parts bulletin

No. 95-11

Revised November 1997

Shift spool for Alpha One & Alpha One Generation II

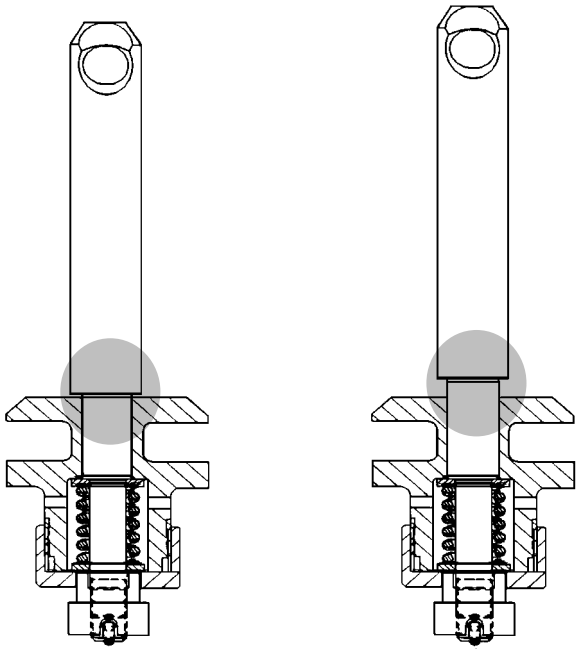
The Alpha One Generation II counter rotation drive has been changed to allow the propeller to ratchet while in forward gear. The new style shift spool assembly (818349A1) is a dual acting shift spool that allows the propeller to ratchet upon deceleration while in forward gear like the standard rotation drive does. This eliminates the possibility of the engine stalling when the boat is rapidly decelerated to an idle speed without shifting into neutral.

- All Alpha One and Alpha One Generation II counter rotation service replacement drives.
- All Alpha One and Alpha One Generation II counter rotation lower units complete.
- The old style shift spool (19755A2) will supersede to the new (818349A1) shift spool.

OLD STYLE SHIFT SPOOL
19755A2

NEW STYLE SHIFT SPOOL
818349A1
